Supplier Visit #2

CDCQ Press/Mould– Foshan

New 20ton (2U/2D) Press machine

Review –
Changes & Improvement point

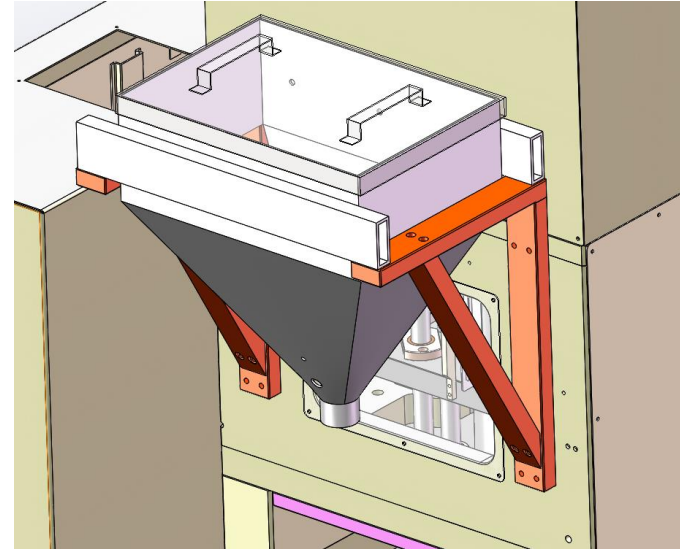
Increase the hopper capacity to 80KG
将料斗容量增加到80公斤

20KG

回复: **80KG**太大没有位置放
料斗容量变更为**40KG**

Re: 80KG is too big and there is no place to put it
Hopper capacity change to 40kg

**OK
Completed**

TAMAGAWA

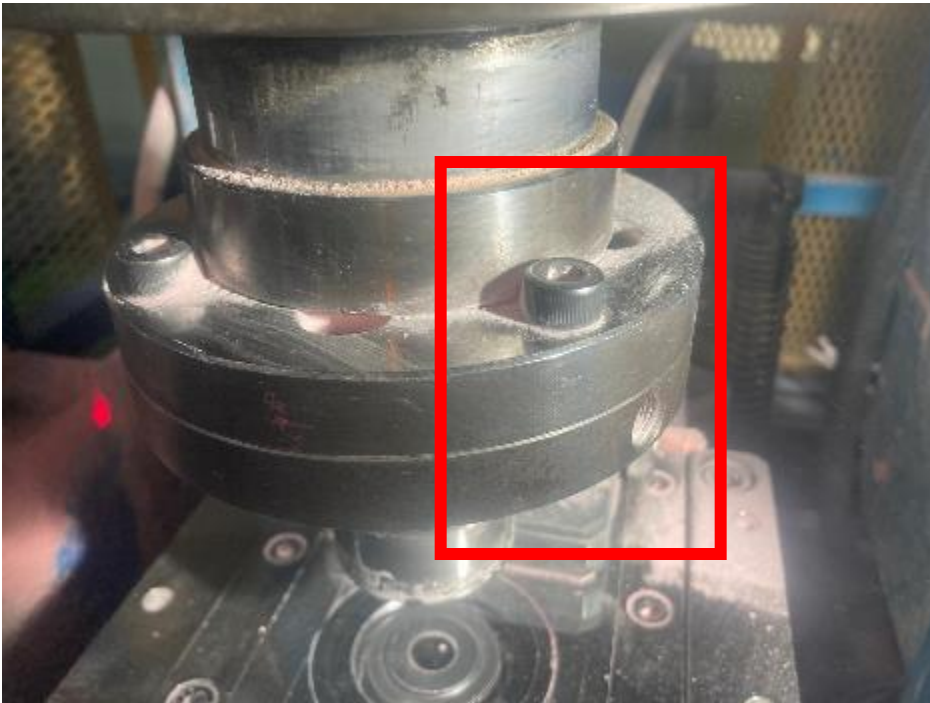
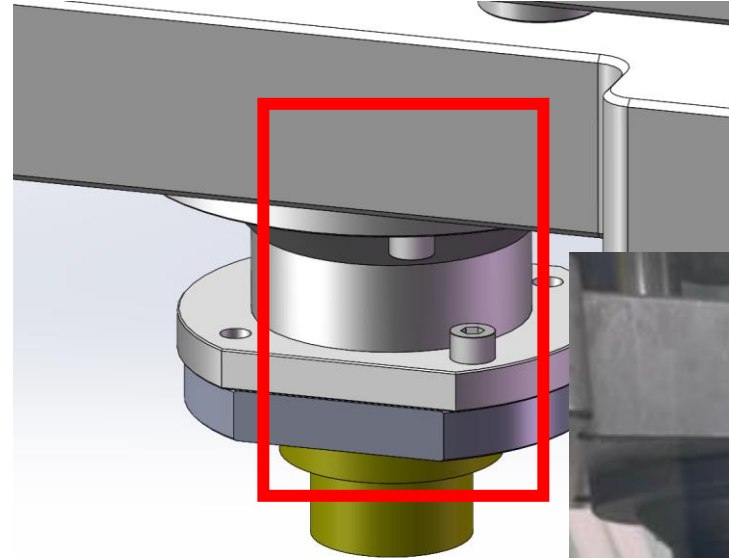
- The alignment shifts during pressing or after exceeding the maximum load by double pressing. The screws come loose (M6 -> M8).
- When setting up the upper punch, it is difficult to align the screw by turning it downwards.

Require similar like Tamagawa

回复：創芯旗

Re: Will comply as per Maruwa request

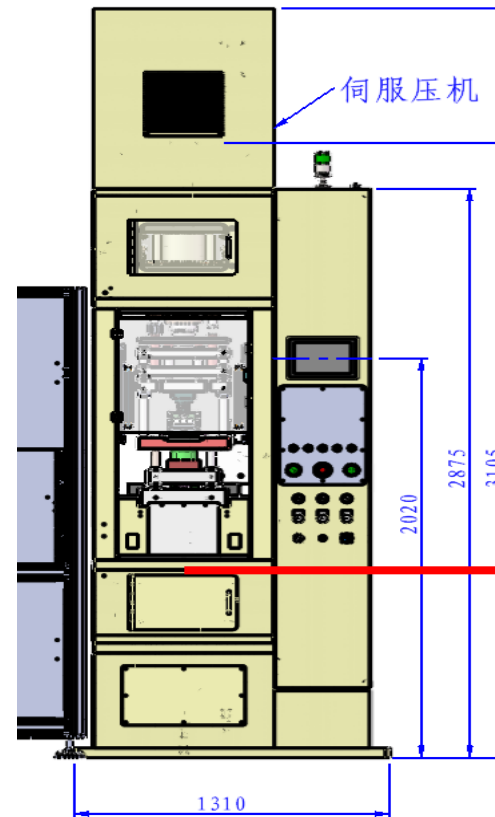
d. Equipment – panel position 回复: 取料机建议放到机台左侧, 方便换模具及操作机台
 Re: It is recommended to put the reclaimer on the left side of the machine to facilitate the change of mold and the operation of the machine

**Please provide the layout drawing*

Screw direction changes OK

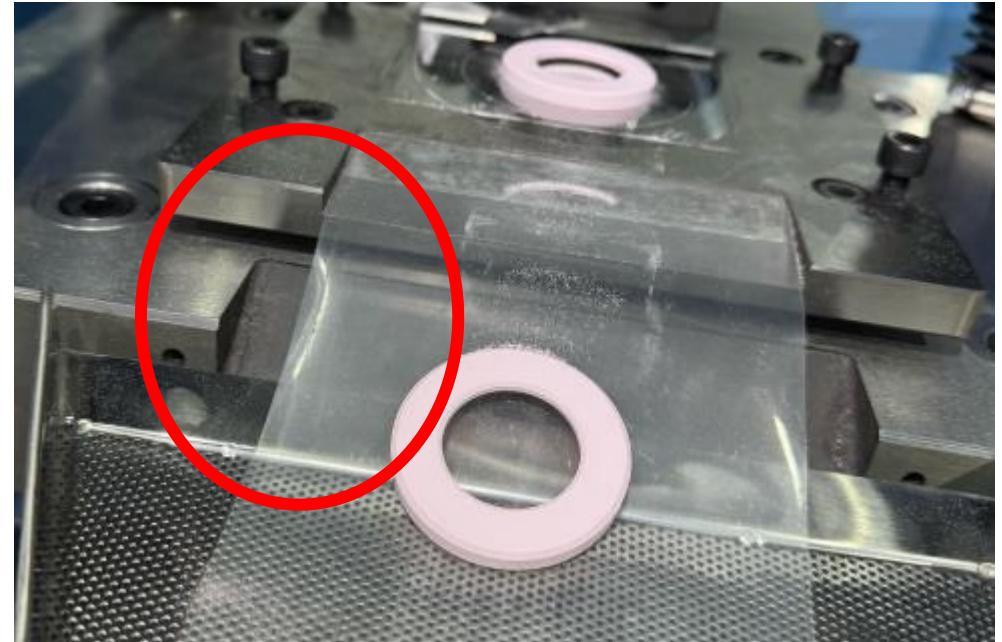
Max limit
 → No any gauge below this line

Maruwa requesting the die plate groove angle to be in the range of $6.6^{\circ} \sim 7.0^{\circ}$
=> Final angle will be 6.8°

OK

Completed the modification
Angle : 6.8°

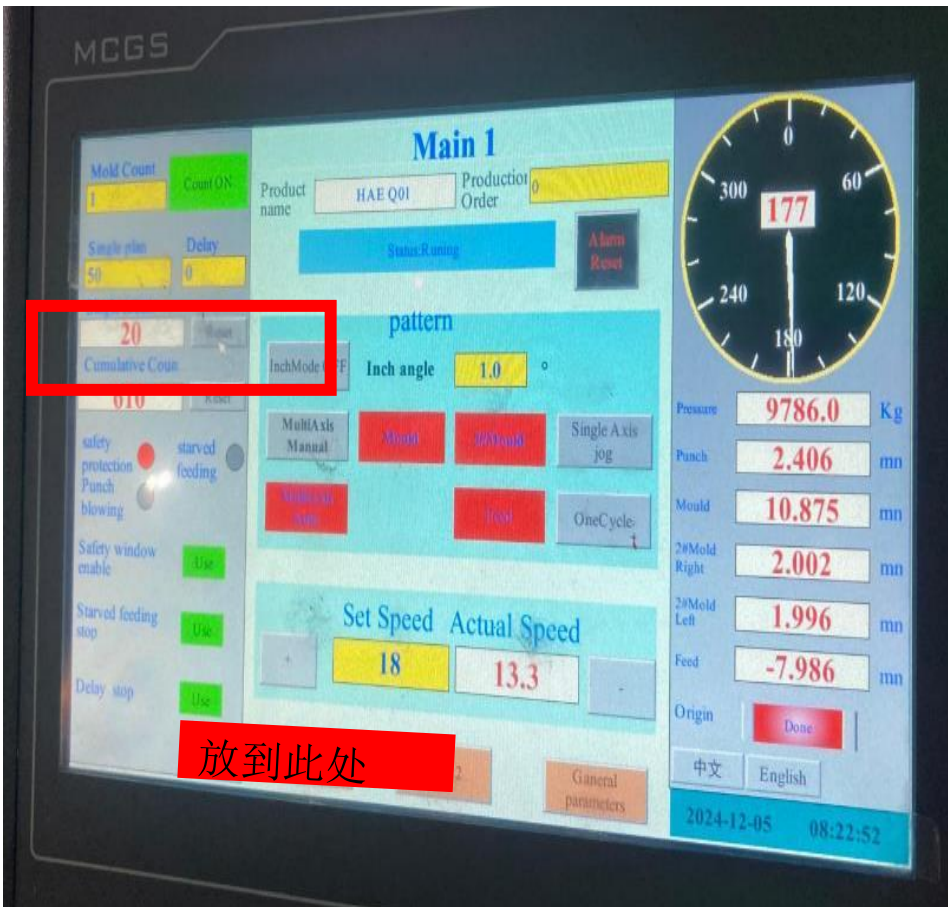
The operator mistook it for the mold cleaning counter and reset it.

→ A confirmation screen is required for mould cleaning

→ Relocate – mould cleaning button separately : operator always mistake

回复：位置更新，后续会出示意图

Re: Location update, intent will be shown later

Mould cleaning reset button separate with quantity reset

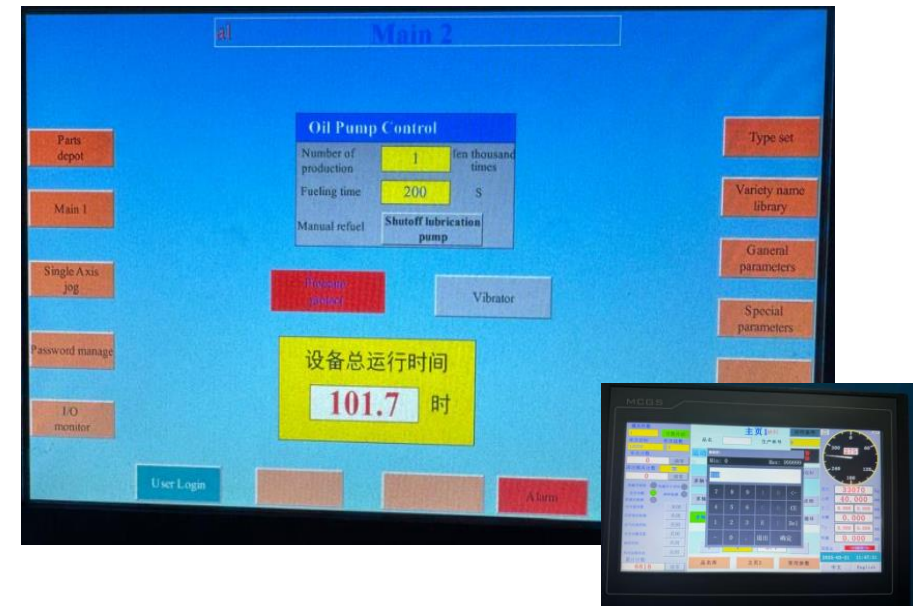
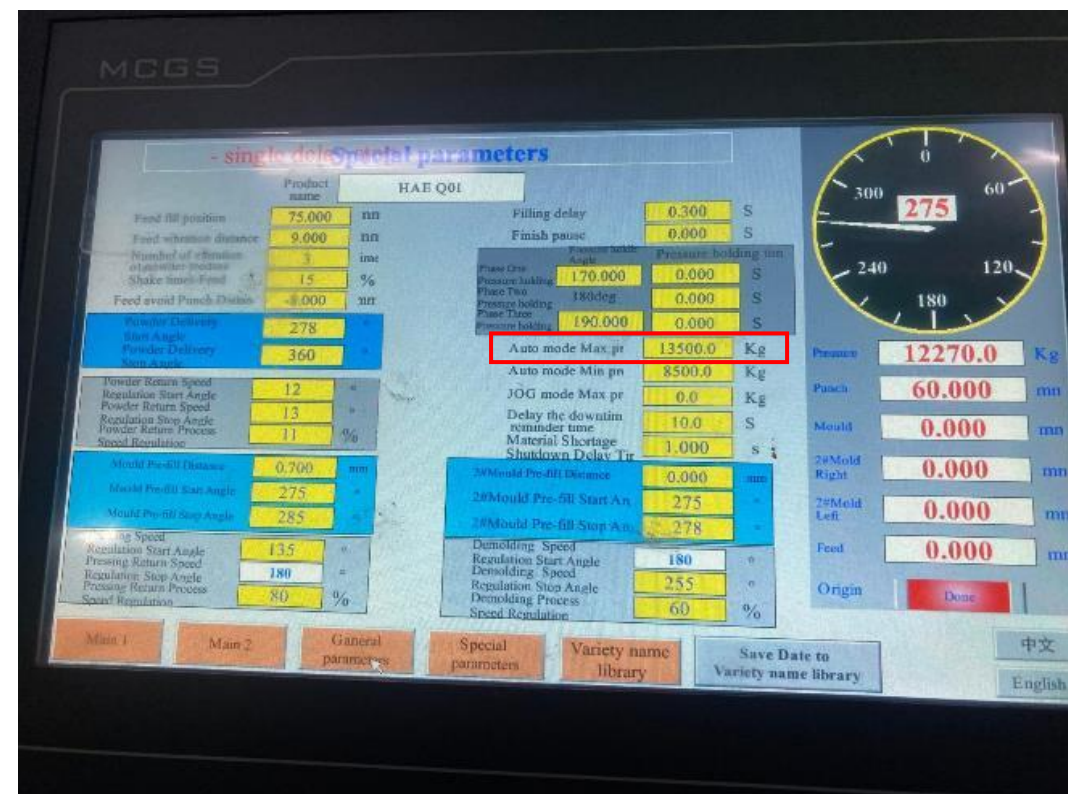
- It will be possible to control the pressure input.
- It will make an emergency stop the moment the pressure reaches this level or exceeds this level. The current function is slow to stop, and will only make an emergency stop once the pressure reaches 15 tons, 19 tons or more.

Need to add in auto stop when exceed setting spec

回复：售后跟踪，新机处理好才出机

Re: The pressure setting not activated → will update the software for to enable & disable

Similar software will be update for DP21

All parameter setting will be protected with password where the login will be recorded in the log

Parameter setting => password protected

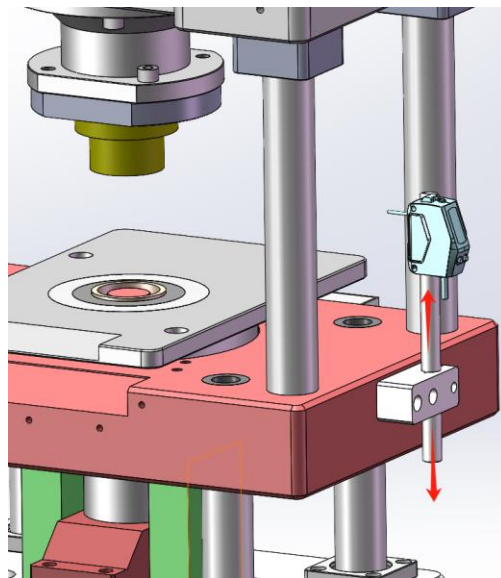
b. Barrier sensor – Custain sensor 回复: 新设备安装安全光栅 (OK)

Completed barrier sensor

IoT – PLC Setting

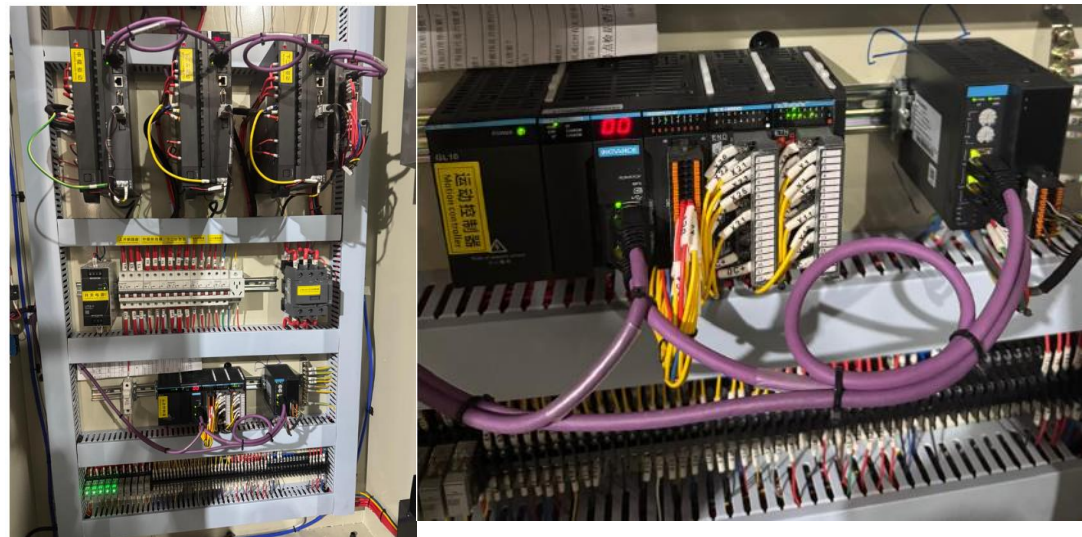
- * Data transfer parameter

add another 4 in the front

CDCQ – Understood & provided
